**ADDENDUM NO. 2**

PROJECT TITLE:  
**REPLACEMENT OF  
 BRIDGE NO. 06896, ROUTE 156  
 OVER ARMSTRONG BROOK**

TOWN:  
**OLD LYME**  
 DRAWING TITLE:  
**RIGHT-OF-WAY  
 PLAN**

PROJECT NO.  
**104-175**  
 DRAWING NO.  
**ROW-1**  
 SHEET NO.  
**03.02.A2**

SHEET NO.  
**03.19.A2**

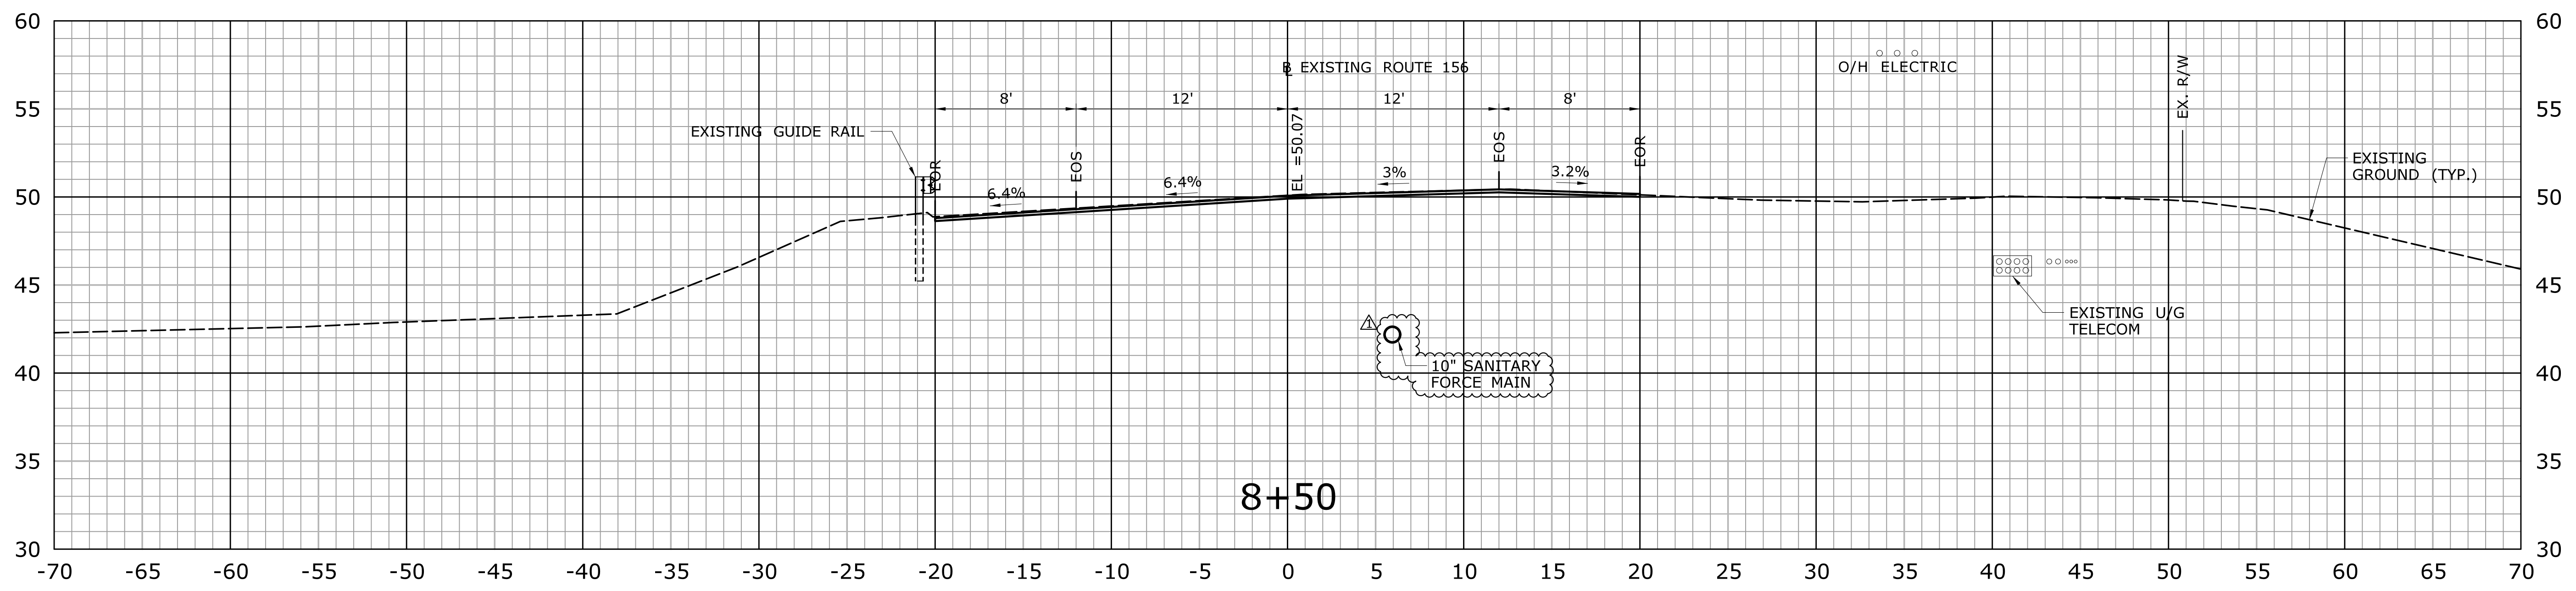
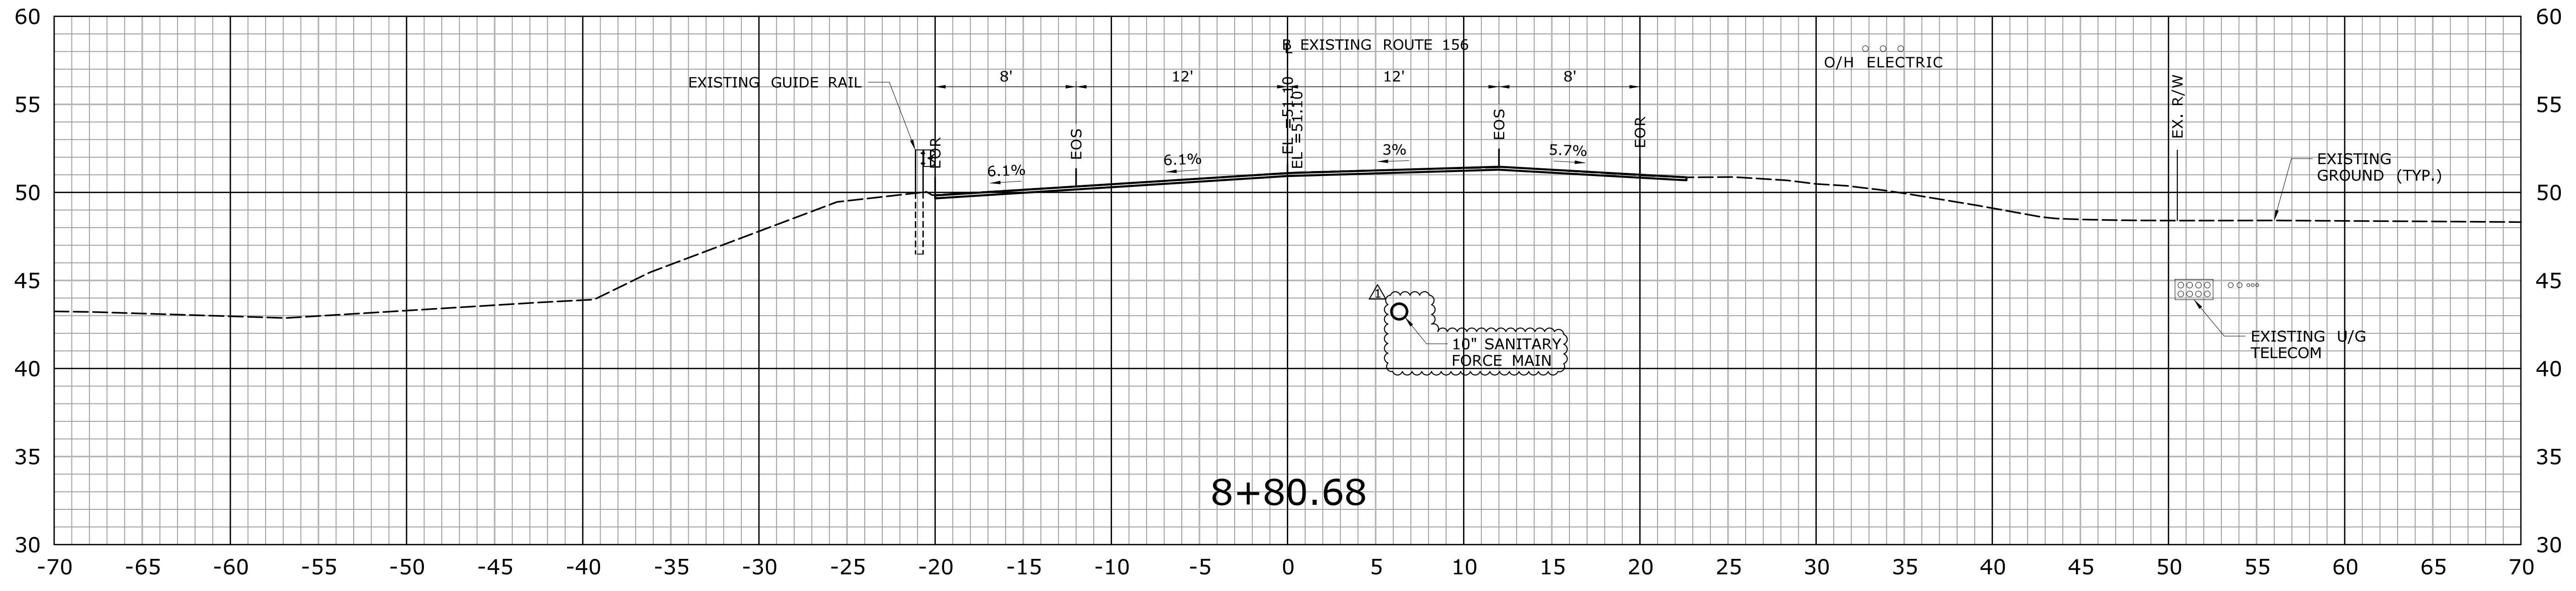
REV.	DATE	REVISION DESCRIPTION	SHEET NO.
1	1.31.25	ADD SANITARY FORCE MAIN	03.19
